ITEM III-A: DESIGN REVIEW PERMIT – 8601 FOOTHILLS BOULEVARD – NIPA PCL50–ROSEVILLE SELF-STORAGE – PL15-0058

The applicant requests approval of a Design Review Permit to allow construction of a self-storage facility and caretaker's residence, totaling approximately 110,000 square feet.

Figure 3: Project Landscaping and Site Plan

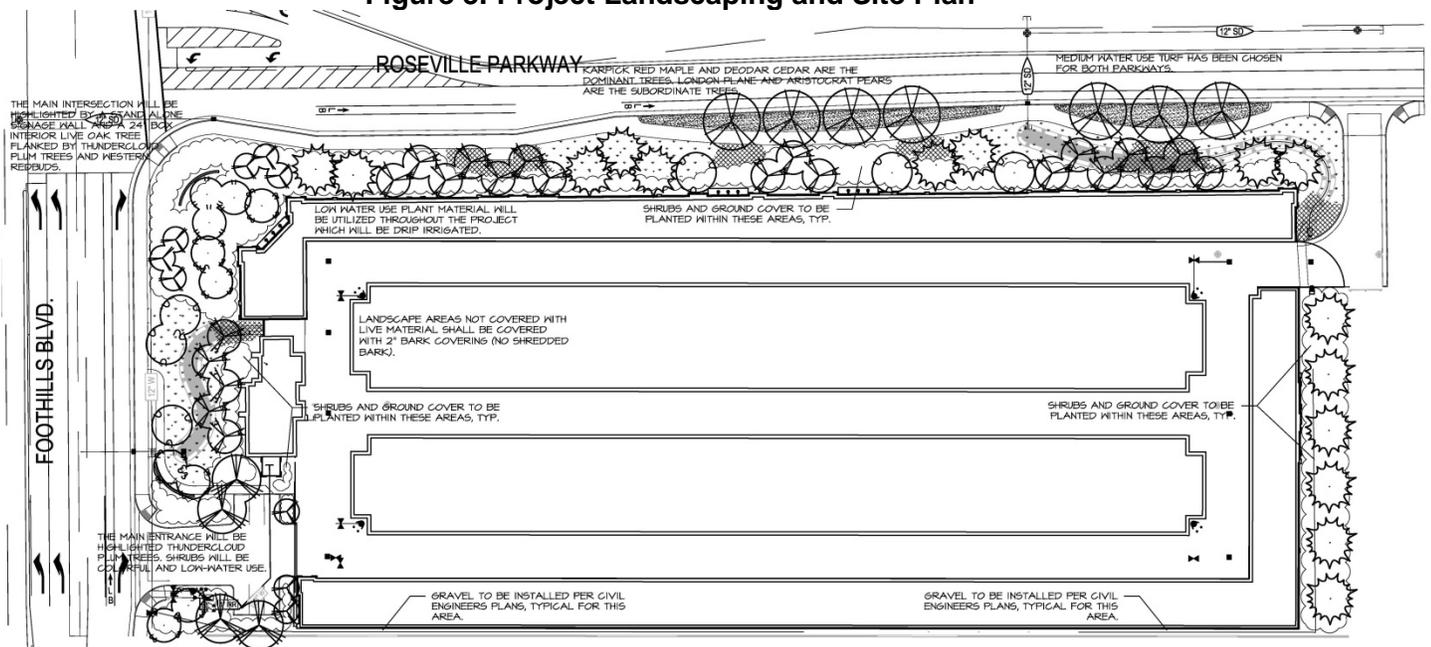
The primary point of access for the Project will be a driveway on the southwestern corner of the site, which will allow both ingress and egress. A secondary point of access is proposed on the northeastern corner, which would outlet to the portion of Niblick Drive which will be improved for the project. An emergency access gate will be placed on Niblick Drive just to the south of this driveway, so that drivers may only use the roadway to access Roseville Parkway.

Figure 4: Area Affected by Setbacks

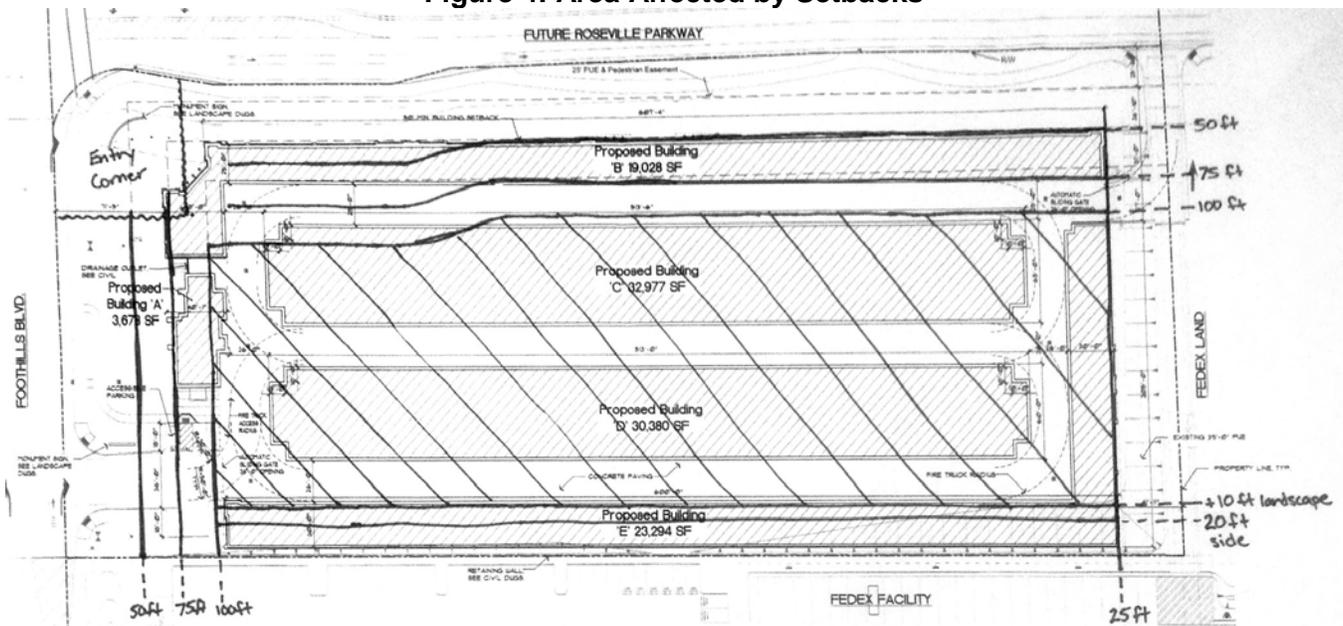
As shown in Table 1, the project design meets the rear setbacks and meets or exceeds the landscape setbacks on both the Foothills Boulevard and Roseville Parkway frontages, but does not meet most of the building setbacks. The project also includes the 35-foot by 35-foot corner entry point area. Staff is supporting this design for the following reasons: existing development patterns do not adhere to these setbacks, adjacent planning areas do not include these setbacks, and the applicant is maintaining the landscape setbacks on all street-facing sides. Each of these points is discussed in more detail below.

While the applicant is not meeting most building setbacks, the minimum landscape setbacks along all street-facing sides of the project are being provided. Staff is supporting this design, as it strikes a reasonable balance between maintaining setbacks and providing developable area, and will be consistent with the character of development in the NIPA along Foothills Boulevard and the future Roseville Parkway. While the project does not strictly adhere to the setbacks of the NIPA, it does conform to the overall design concept, principles, and goals of the NIPA and is harmonious with the surrounding developments; on these grounds, staff believes the finding can be made that the project is consistent with the applicable goals and objectives of the Specific Plan. Pursuant to the City of Roseville Zoning Ordinance Section 19.74.010.C.2.b.1, the Design Committee may approve "Design Review permits which deviate from the requirements or standards of adopted Community Design Guidelines or an applicable adopted specific plan."
